Intersection ID: 18174	Main Street: EAGLEWOOD_AV	Cross Street: MONROE_RD	Location:	NW
ADA ID: AE14EE217212	Ramp Type: PerpDiag	Initial Pass/Fail: Fail	Overall Compliance: No	Severity Score: 8.75

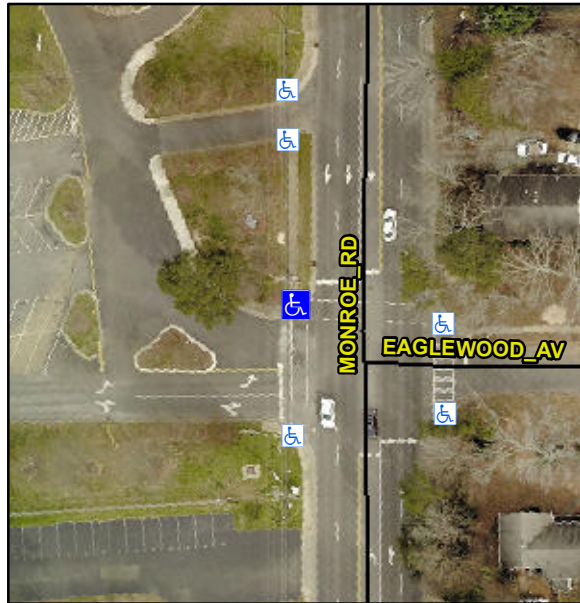
**Not Found, R304.5.1**

Compliance	Description	Data	Compliance	Description	Data
N/A	Ramp Length (in)	73.0	Yes	Ramp Slope (%)	5.2
No	Ramp Width (in)	41.0	Yes	Ramp XSlope (%)	0.8
N/A	Flare Type LT	N/A	N/A	Flare Type RT	N/A
N/A	Flare Slope LT (%)	N/A	N/A	Flare Slope RT (%)	N/A
N/A	Flare Traversable LT?	N/A	N/A	Flare Traversable RT?	N/A
N/A	Landing Length (in)	N/A	N/A	DWS Provided?	N/A
N/A	Landing Width (in)	N/A	N/A	DWS Contrast?	N/A
N/A	Landing Slope (%)	N/A	N/A	DWS Length (in)	N/A
N/A	Landing X Slope (%)	N/A	N/A	DWS Full Width?	N/A
N/A	Landing Curb? (Y/N)	N/A	N/A	DWS Offset (in)	N/A
N/A	Shared Landing?	N/A			
N/A	Gutter Ponding?	N/A	N/A	Gutter Slope (%)	N/A
N/A	Gutter Lip Ht (in)	N/A	N/A	Gutter X Slope (%)	N/A
N/A	Painted X Walk1?	Yes	N/A	Painted X Walk2?	Yes
	X Walk 1 Direction	To S		X Walk 2 Direction	To E
N/A	X Walk 1 Width (in)	86.0	N/A	X Walk 2 Width (in)	108.0
	X Walk 1 Slope (%)	0.7		X Walk 2 Slope (%)	1.8
	X Walk 1 X Slope (%)	0.9		X Walk 2 X Slope (%)	0.5

**Remove & Replace Curb Ramp With Two New Directional Ramps or Equivalent.**
